Yarra Planning Scheme Amendment C191yara

Comparison of the exhibited version of the amendment documents, excluding maps that are addressed separately in Attachment 8, and the version of the amendment documents for adoption, and the reasons for the changes.

Schedule 17 to the Design and Development Overlay (DDO17)

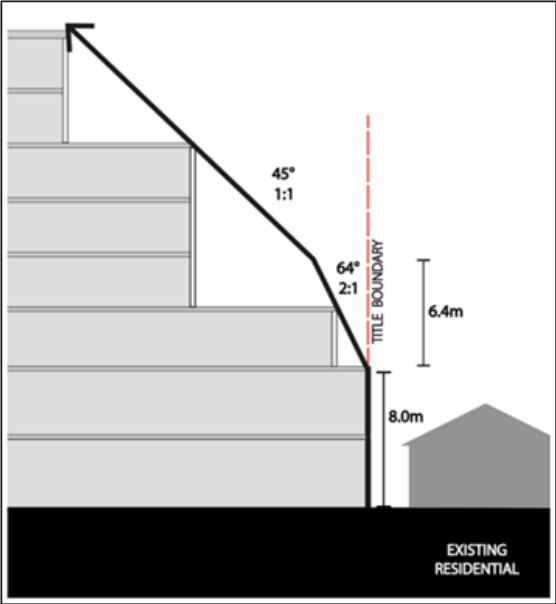
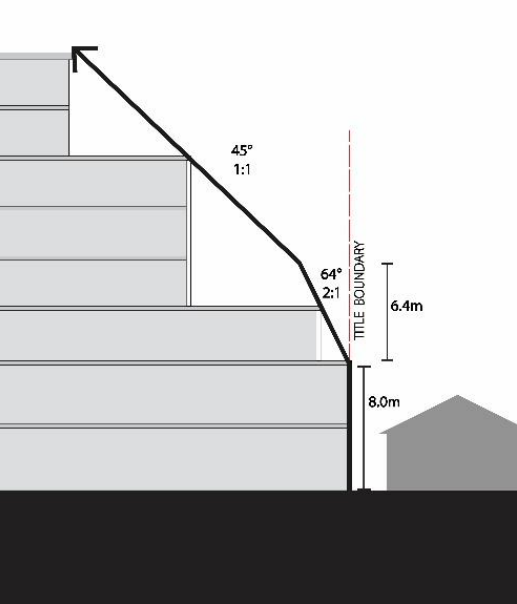
11.	Figure 1 to schedule 17 – Residential interface with an existing laneway	<p>Figure 1 to schedules 25 – Interface with an existing laneway</p> <p>Figure 1 to schedules 26 – Interface with an existing laneway</p> <p>Figure 1 to schedules 27 – Interface with an existing laneway</p> <p>Figure 1 to schedules 28 – Interface with an existing laneway</p>	<p>The version of the DDO25, DDO26, DDO27 and DDO28 for adoption:</p> <ul style="list-style-type: none"> • Replace the description of Figure 1 from 'residential interface' to 'Interface with an existing laneway'; and • Delete the words 'existing residential' in Figure 1 cross-sections. <p>These drafting changes will ensure that Figure 1 accurately reflect and relate to the rear interface provisions of 'Interface I' in Table 1 – Street Wall Heights and Setbacks.</p>

12.	<p>Figure 2 to schedule 17 – Residential interface direct abuttal</p>	<p>Figure 2 to schedules 25 – Interface direct abuttal Figure 2 to schedules 26 – Interface direct abuttal Figure 2 to schedules 27 – Interface direct abuttal Figure 2 to schedules 28 – Interface direct abuttal</p>	<p>The version of the DDO25, DDO26, DDO27 and DDO28 for adoption:</p> <ul style="list-style-type: none"> • Replace the description of Figure 2 from 'residential interface' to 'Interface direct abuttal'; and • Delete the words 'existing residential' in Figure 2 cross-sections. <p>These drafting changes will ensure that Figure 2 accurately reflect and relate to the rear interface provisions of 'Interface I' in Table 1 – Street Wall Heights and Setbacks.</p> <p>These changes were supported by the Panel.</p>

Plan 1: Height and Interface Plan – Precinct 1 Richmond Station

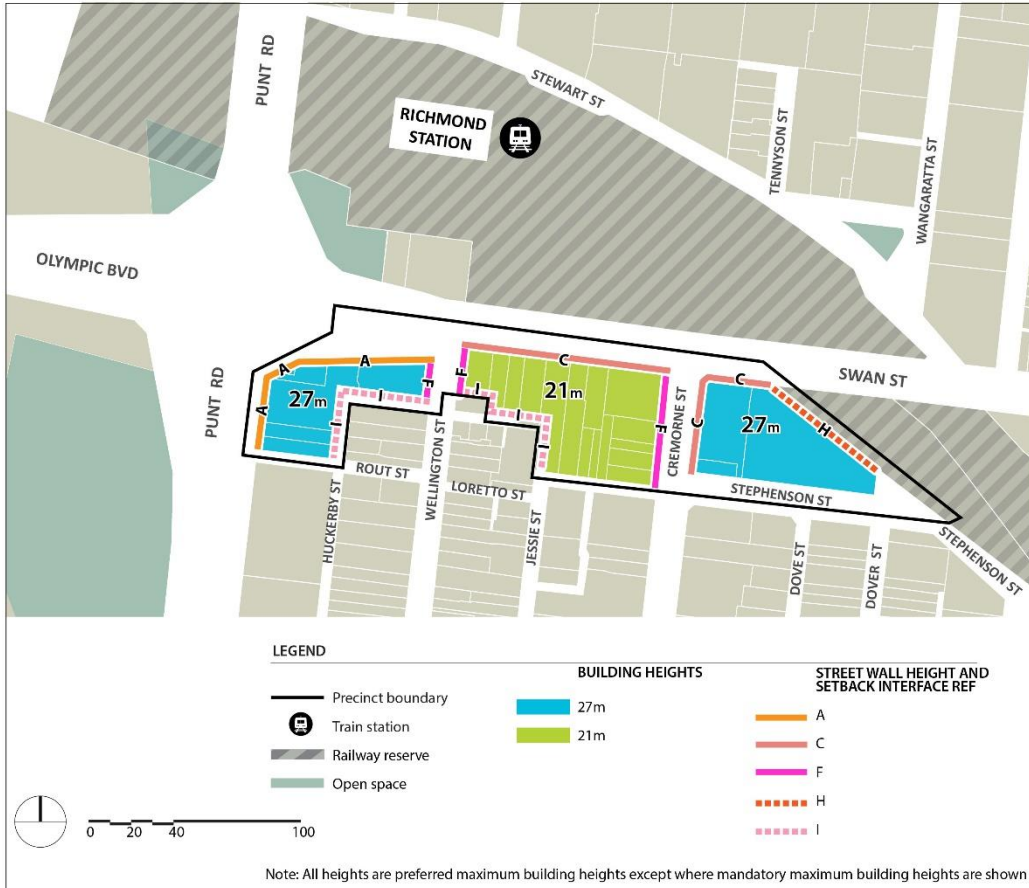
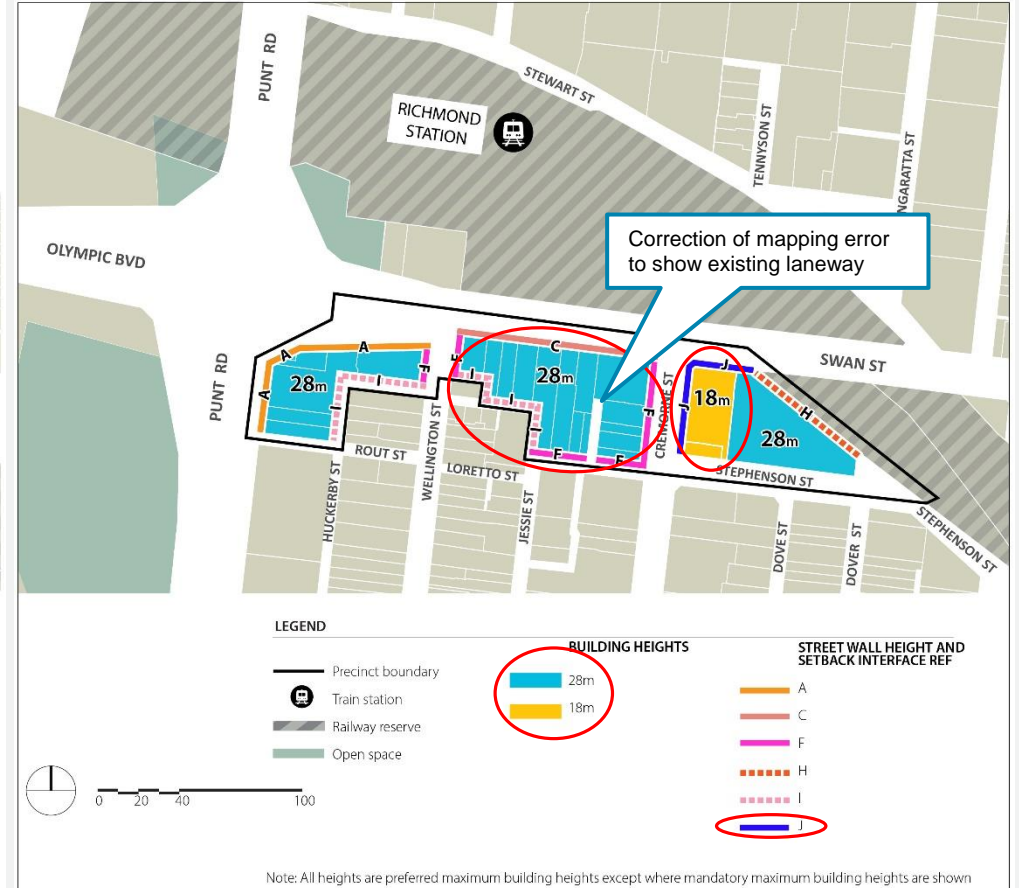
ROW NO.	REQUIREMENT	DDO17 EXHIBITED METRICS (* DENOTES MANDATORY)	DDO25 FOR ADOPTION METRICS (* DENOTES MANDATORY)	REASON FOR CHANGE
21.	Maximum building height	<u>Height of 27m</u> 60 Swan Street (Precinct Hotel) 5 Cremorne Street	<u>Height of 18m</u> 60 Swan Street (Precinct Hotel) 5 Cremorne Street	<p>The Precinct Hotel is an individually significant place. Following exhibition, Council's heritage consultant GJM Heritage reviewed the controls and recommended a proposed height of 18m (approximately 5 storeys) to protect the visual prominence of the landmark building. The proposed lower height will help ensure the Precinct Hotel can be read as a three-dimensional form from both streets.</p> <p>The Panel supported this change.</p>

22.		<u>Height of 27m</u> 371 – 377 Punt Road 2-14 Swan Street	<u>Height of 28m</u> 371 – 377 Punt Road 2-14 Swan Street	<p>The approved Queens Parade DDO (DDO16) assumes eight storeys can be accommodated within a 28m height limit, whereas the Swan Street DDO17 as exhibited, assumes eight storeys can be accommodated within a 27m height limit. As such, the schedules for adoption have been amended to show 28m instead of 27m, in accordance with the provisions contained in DDO16.</p> <p>This change supports a consistent approach to drafting Yarra's DDOs for its activity centres.</p> <p>The Panel supported this change.</p>

30.	Boundary wall setback (new requirement inserted into DDO25 Table 1)	<i>40 Swan Street</i> <ul style="list-style-type: none"> • No proposed boundary wall setback for 40 Swan Street 	<u>Interface I</u> <i>40 Swan Street</i> <ul style="list-style-type: none"> • At 40 Swan Street only, development not built on a common boundary should provide a minimum setback of 4.5 metres to the common boundary. 	<p>Council's Urban Design expert witness recommended there should be a requirement that development at 40 Swan Street (not built on a common boundary) should provide a minimum setback distance of 4.5m to that common boundary (Ms Hodyl's evidence report, Recommendation 6, Page 3 at [25]). She recommended this be a preferred development outcome and not a mandatory provision.</p> <p>This change is considered appropriate as it will enhance the protection of the amenity of adjoining properties.</p> <p>The Panel supported this change.</p>

Plan 2: Access and Movement Plan – Precinct 1 Richmond Station

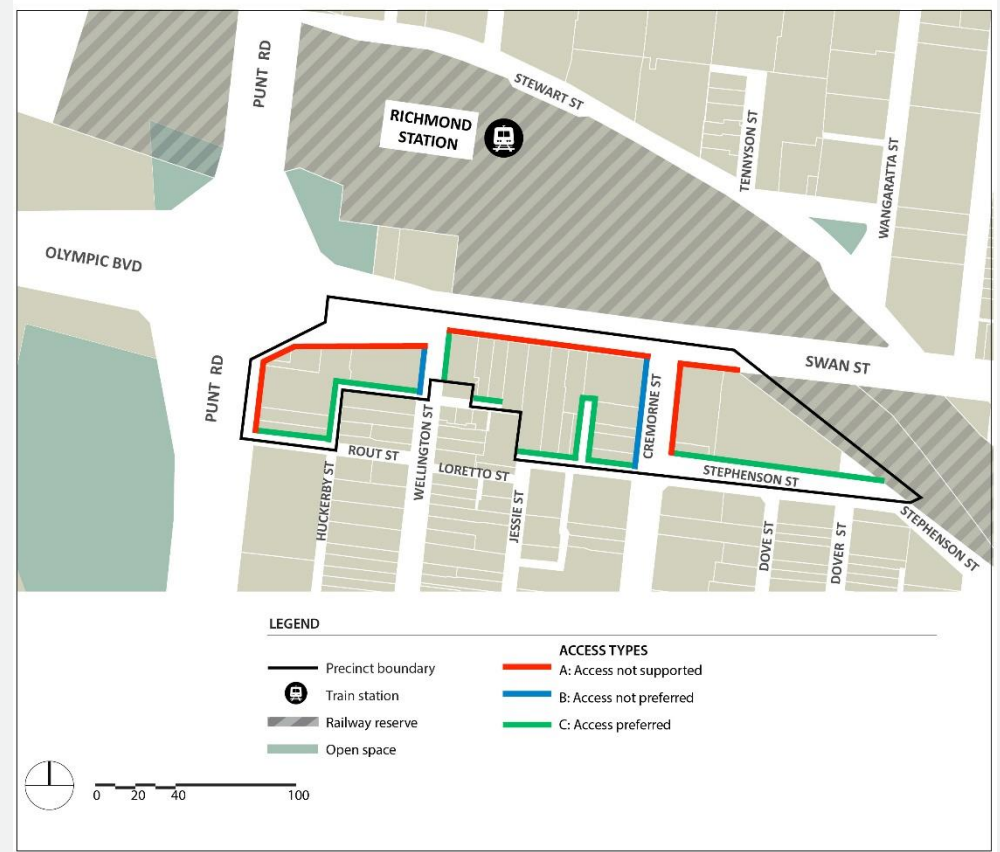
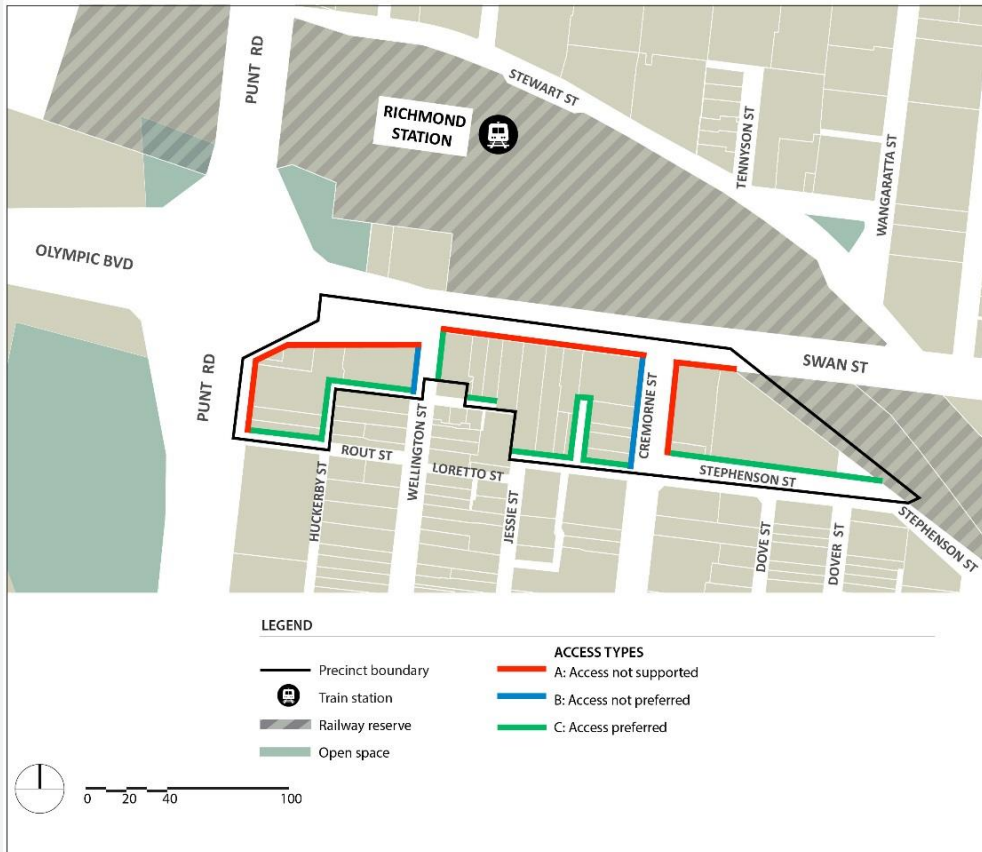
ROW NO.	DDO17 EXHIBITED SECTIONS (* DENOTES MANDATORY)	DDO25 FOR ADOPTION SECTIONS (* DENOTES MANDATORY)	REASON FOR CHANGE
18.	<p>Vehicle and pedestrian access</p> <p><i>Development must provide vehicular access from rear lanes or from side streets in the preferred locations in the Access and Movement Plans (Plan 2, 4, 6 and 8) of this schedule except in locations identified as “Left in - Left Out Access Permitted” in the Access and Movement Plans (Plan 2, 4, 6 and 8) of this schedule.</i></p> <p><i>Development identified as “Left in - Left Out Access Permitted” in the Access and Movement Plan must limit the width of vehicle crossovers and incorporate ‘Left in’ and ‘Left out’ only vehicle access.</i></p> <p><i>Development with redundant vehicle access points to Swan Street, Church Street and Burnley Street must reinstate the kerb, linemark parking bays, and relocate any parking signs.</i></p> <p><i>Vehicle ingress and egress into development, including loading facilities and building servicing, must be designed to ensure a high quality pedestrian amenity and limit potential conflict between vehicle movements and pedestrian activity.</i></p> <p><i>Pedestrian access to buildings, including upper level apartments, must be from a street or a shared zone shown on the Access and Movement Plans (Plan 2, 4, 6 and 8) of this schedule. Where pedestrian access can only be provided from a laneway at the rear of buildings the pedestrian entrance must be setback from the rear laneway and well-lit to enable safe access.</i></p>	<p>Vehicle and pedestrian access requirements</p> <p><i>Development should provide vehicular access from rear lanes or from side streets in the preferred locations in the Access and Movement Plan 2 of this schedule.</i></p> <p><i>Development with redundant vehicle access points to Swan Street should reinstate the kerb, linemarked parking bays, and relocate any parking signs.</i></p> <p><i>Vehicle ingress and egress into development, including loading facilities and building servicing, should be designed to ensure a high quality pedestrian amenity and limit potential conflict between vehicle movements and pedestrian activity.</i></p> <p><i>Pedestrian access to buildings, including upper level apartments, should be from a street or a shared zone shown on the Access and Movement Plan 2 of this schedule. Where pedestrian access can only be provided from a laneway at the rear of buildings the pedestrian entrance should be setback from the rear laneway and well-lit to enable safe access.</i></p>	<p>The title was amended to add the word ‘requirements’ to be consistent with the naming convention of other sections in the DDO.</p> <p>The section has been amended to clarify the requirements are discretionary by the use of the word ‘should’.</p> <p>The vehicle and pedestrian access requirements relating to Church and Burnley Streets, in addition to ‘Left in - Left Out Access’ and have been removed as they are not relevant or applicable to Precinct 1.</p> <p>The vehicle and pedestrian access requirements have also been amended to remove reference to other ‘Access and Movement Plans’ outside of Precinct 1 and to ensure that they clearly apply to both residential and non-residential development.</p> <p>This change was supported by the Panel.</p>

Plan 1: Height and Interface Plan – Precinct 2 Swan Street Retail Centre

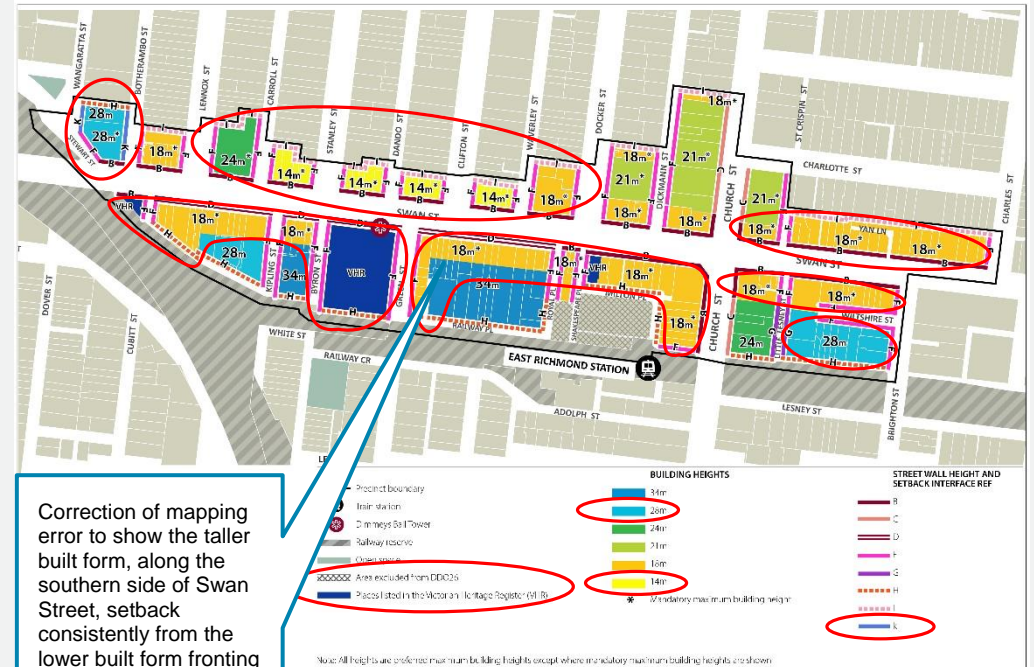
Correction of mapping error to show the taller built form, along the southern side of Swan Street, setback consistently from the lower built form fronting Swan Street (properties 130-208 Swan Street). This better reflects the actual outcomes of the design requirements.

Plan 2: Access and Movement Plan – Precinct 2 Swan Street Retail Centre

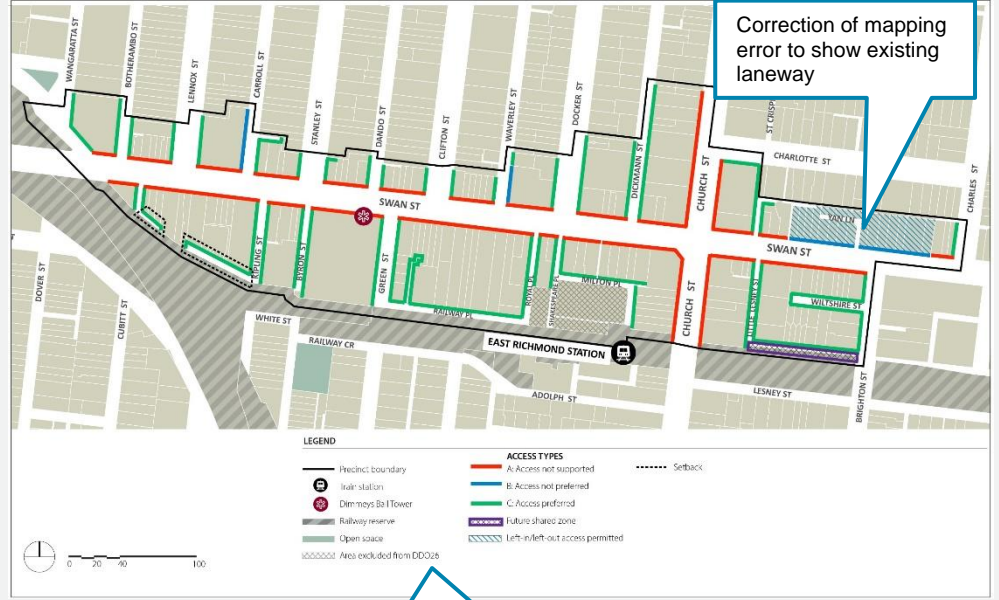
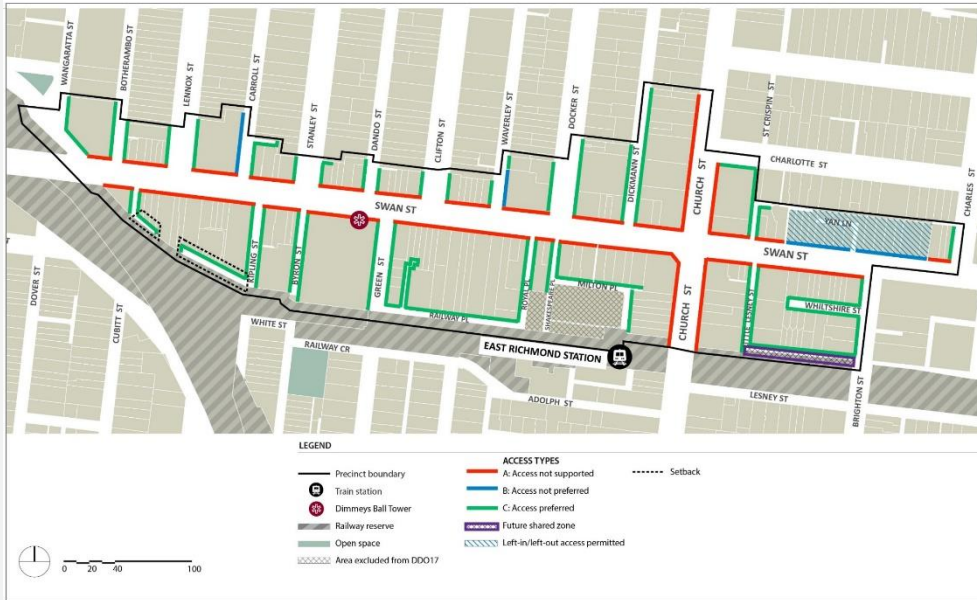
The word 'DDO17' replaced with 'DDO26'.

Plan 1: Height and Interface Plan – Precinct 3 Swan Street East

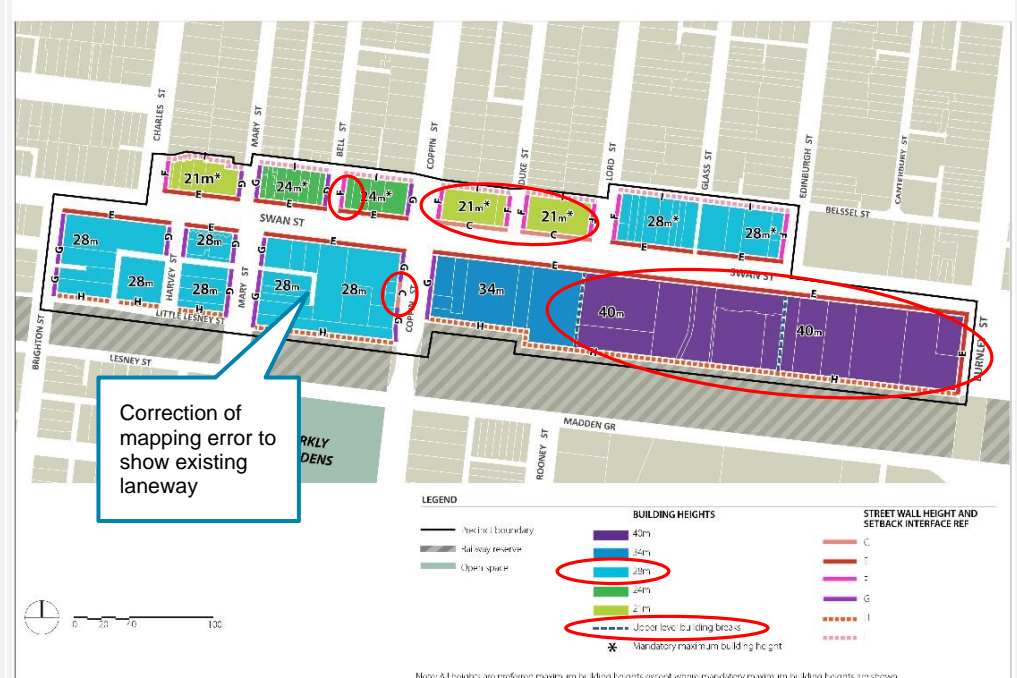
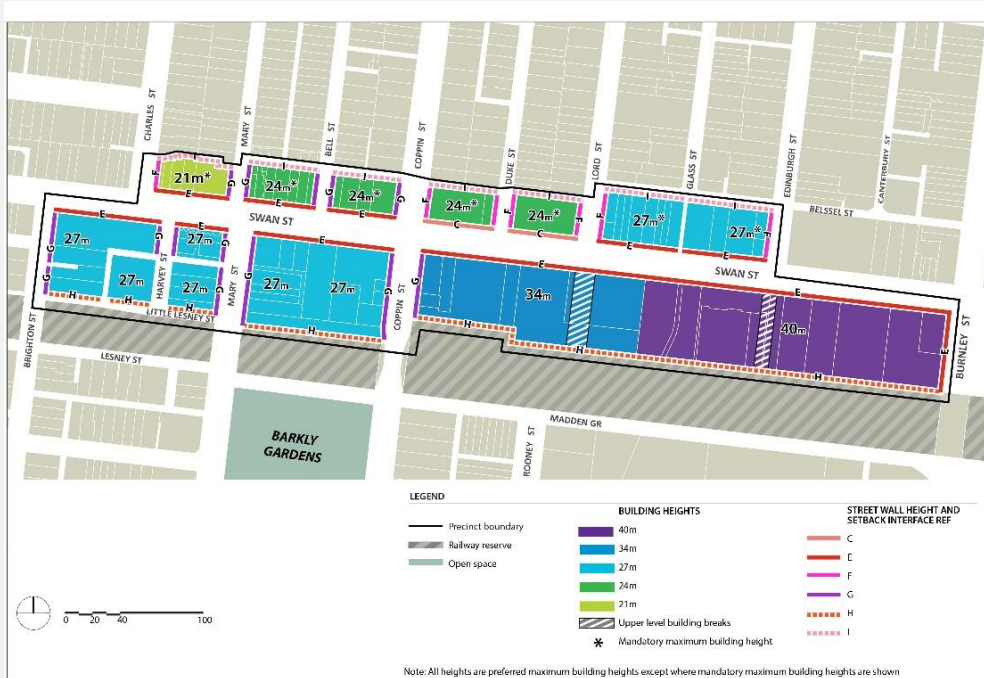
ROW NO.	REQUIREMENT	DDO17 EXHIBITED METRICS (* DENOTES MANDATORY)	DDO27 FOR ADOPTION METICS (* DENOTES MANDATORY)	REASON FOR CHANGE
71.	Maximum building height	<u>Height of 34m</u> 370-380 and the rear of 362-368, Swan Street	<u>Height of 40m</u> 370-380 and the rear of 362-368, Swan Street	DDO17, as exhibited proposed a discretionary maximum building height of 34m for the land at 370-380 and the rear of 362-368 Swan Street. Council's planning expert witness supported the 40m maximum building height being extended to the west to include these sites. He considered this a relatively minor adjustment that would retain the design principle of development stepping up in height towards Burnley Station, to the east.

ROW NO.	REQUIREMENT	DDO17 EXHIBITED METRICS (* DENOTES MANDATORY)	DDO27 FOR ADOPTION METRICS (* DENOTES MANDATORY)	REASON FOR CHANGE
				<p>A 40m maximum height for the land at 370-380 and the rear of 362-368 Swan Street is consistent with the adjoining land to the east and the planning permit (PLN16/0915) approved for the site at 370 Swan Street. The height transition from 34m to 40m is at a logical and appropriate point as it aligns with a proposed upper level building break and the western boundary of 370-374 Swan Street.</p> <p>It is noted that the building heights proposed along the south side of Swan Street in Precincts 3 and 4 are greater than the north side due to the absence of heritage and sensitive interfaces. In addition, several large allotments can accommodate more development. These sites on the south side of the street provide an excellent opportunity to accommodate growth without unreasonably affecting existing residential properties. The rail corridor (which ranges in depth from 29m-45m) provides a significant buffer between these sites and the low scale residential areas to the south.</p> <p>This change was supported by the Panel.</p>
